# COMMON DESIGN ERRORS

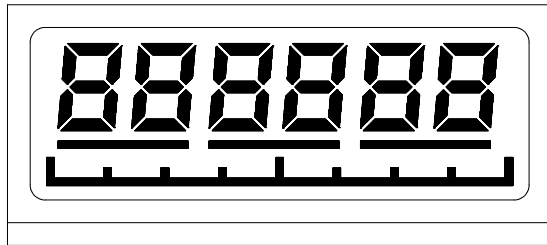
- No view area / seal width allowed for
- No connection area shown

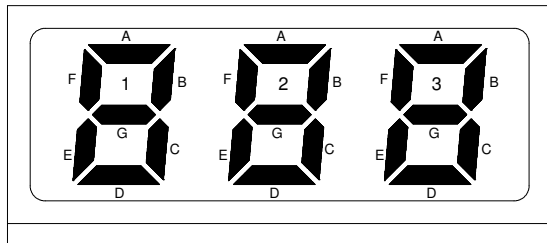
- Segment bar graph blocks off access to connector ledge

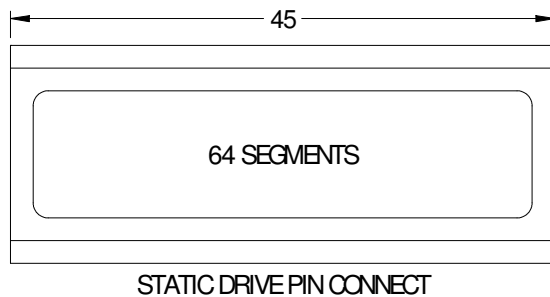
- Impossible to interconnect common lines

- LCD not long enough for quantity of pins required
